EL PASO COUNTY
SPECIAL PERMIT BY USE SUBMITTAL

MONUMENT STEEL STRUCTURES

18910 BASE CAMP ROAD
MONUMENT, COLORADO

Sign Plan_v1-redline.pdf Markup Summary

SECTION THRU PROJECT SIGNAGE

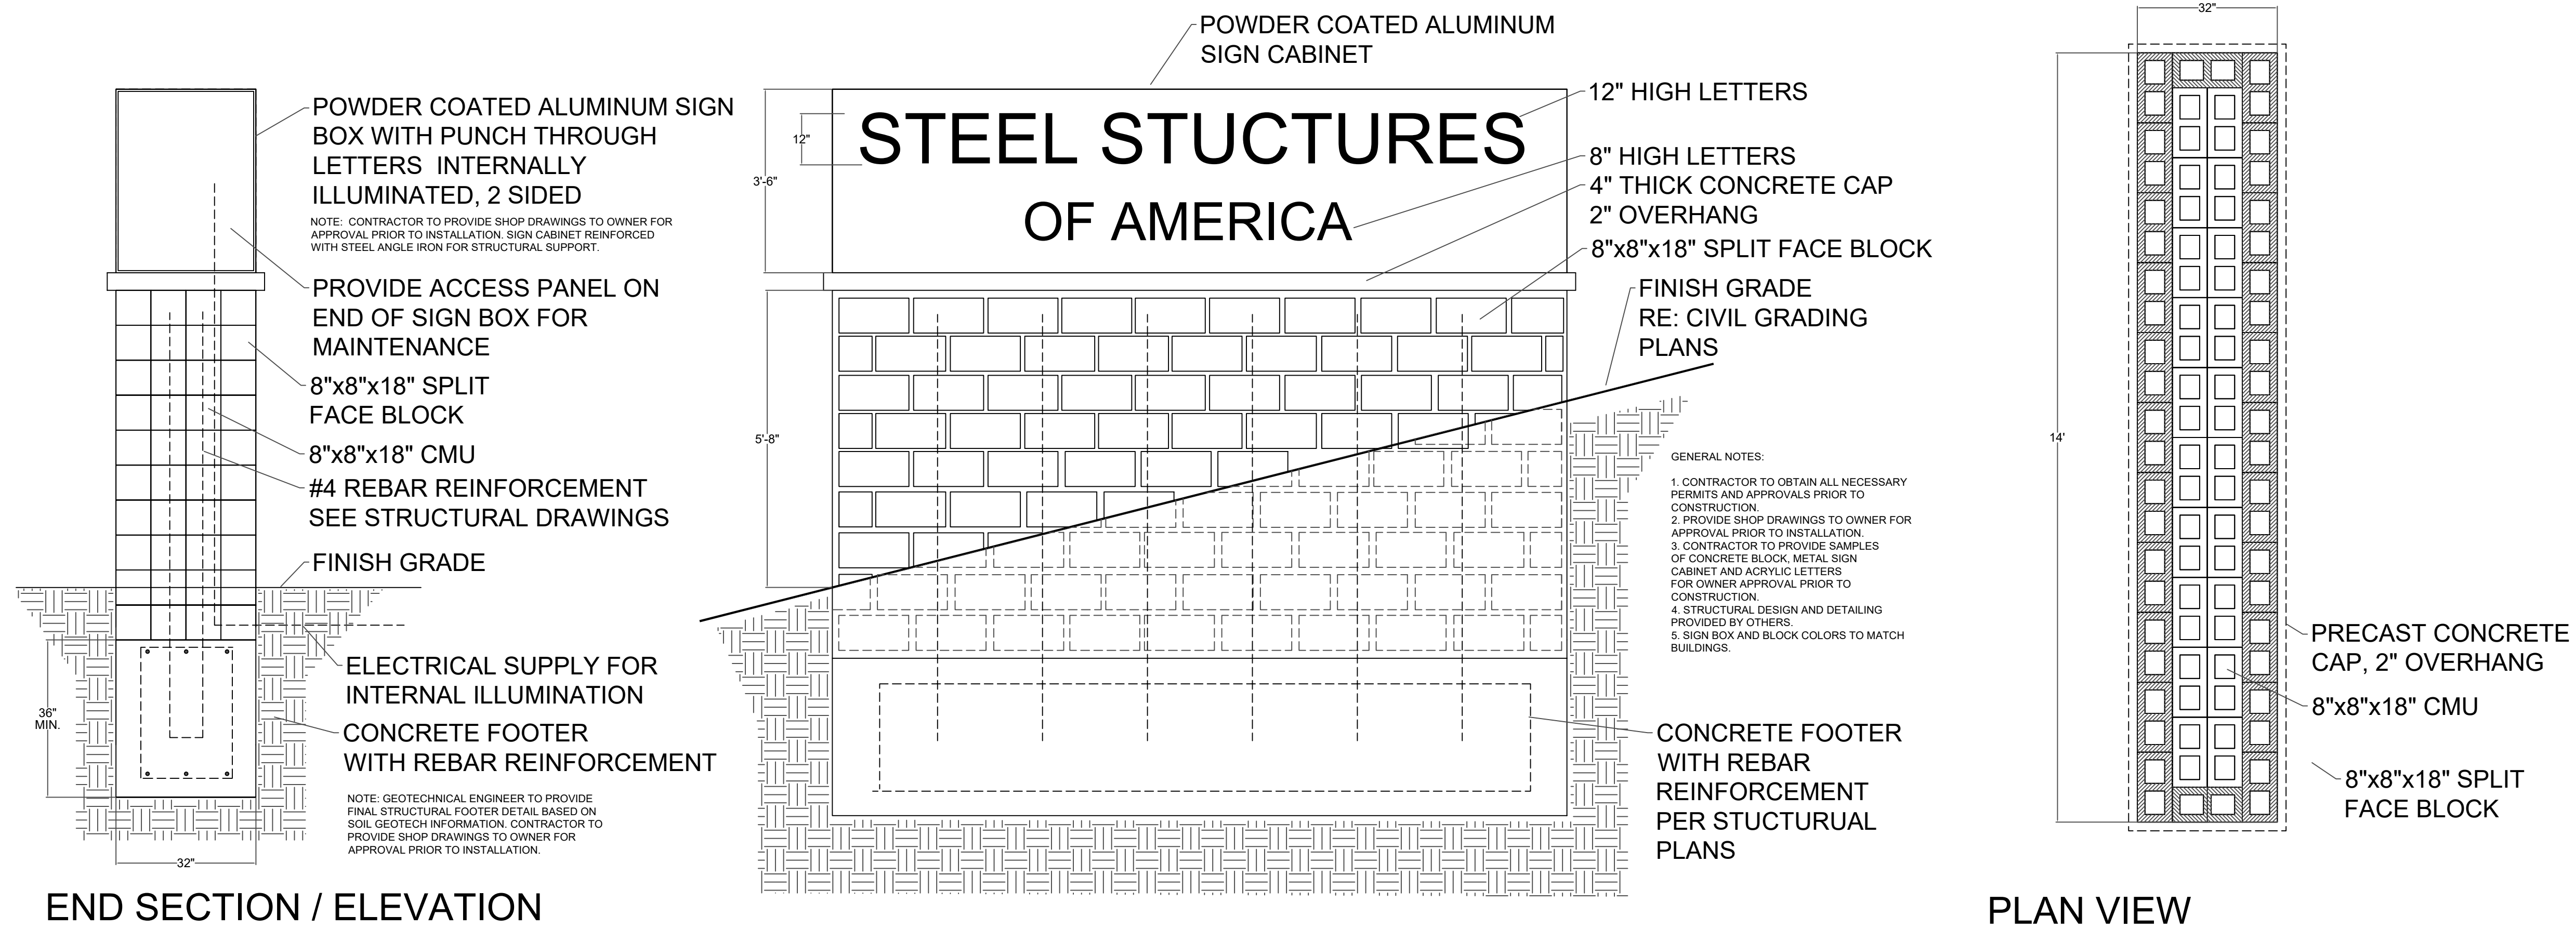
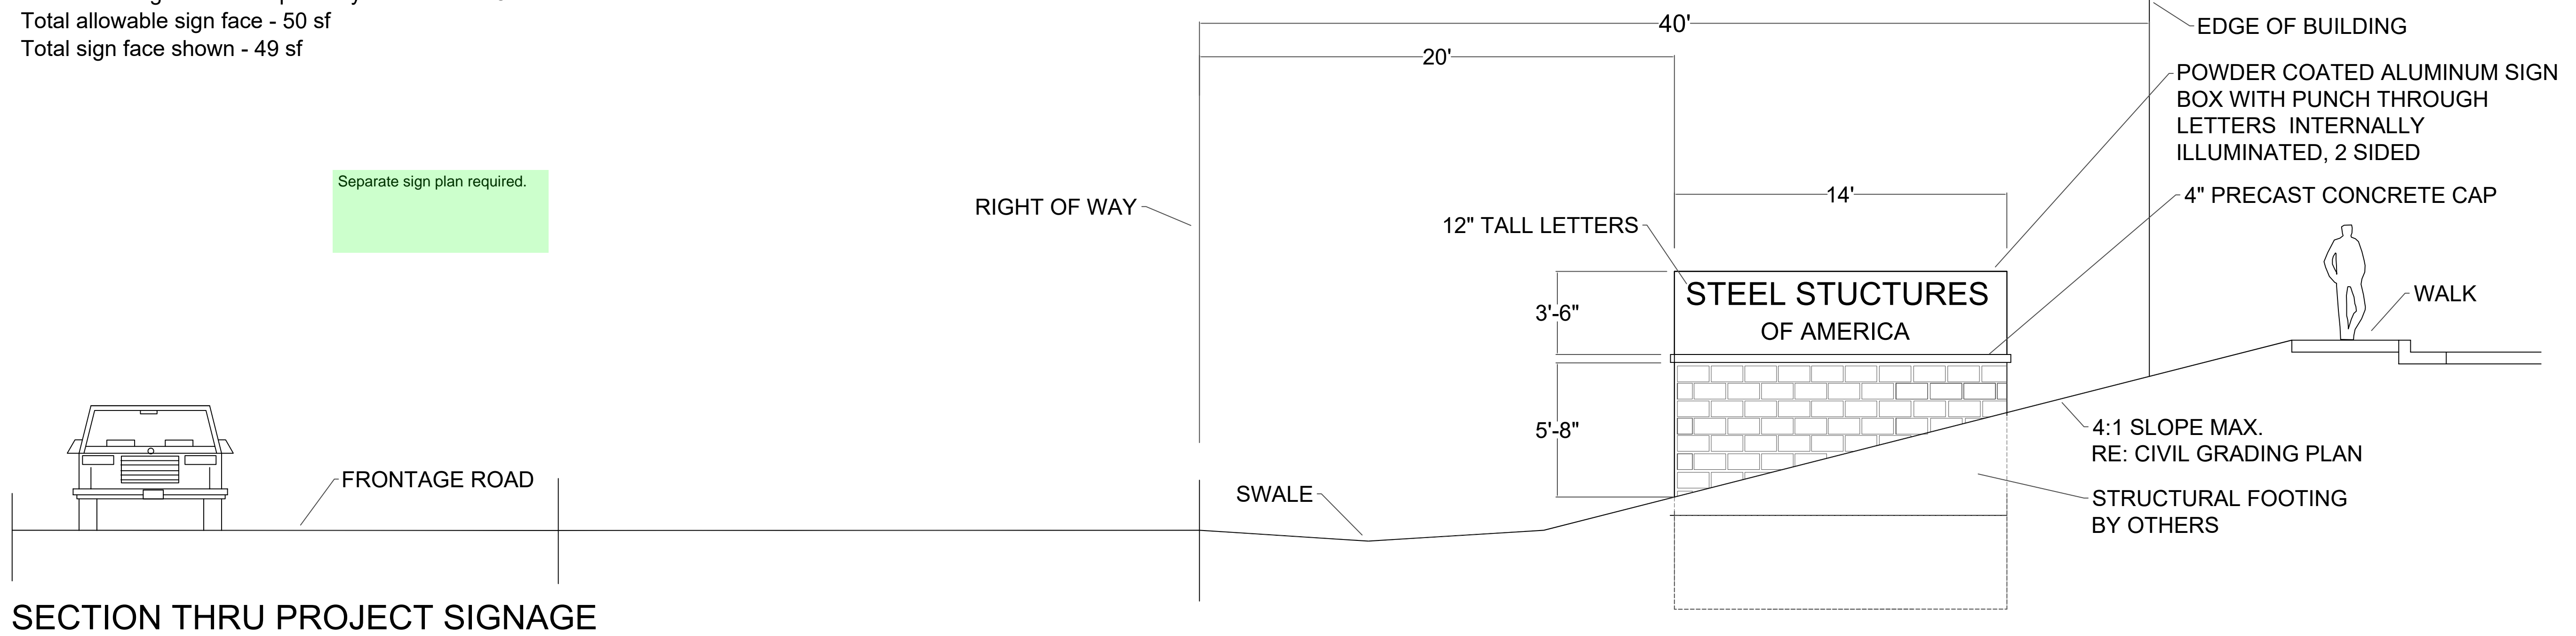
Show the location of the monument sign in the site plan.

EL PASO COUNTY SIGN CODE
Section 6.2.10
Allowable free standing sign - 40 sf
Increase in sign next to Expresway or Arterial - 25%
Total allowable sign face - 50 sf

Total sign face shown - 49 sf

Separate sign plan required.
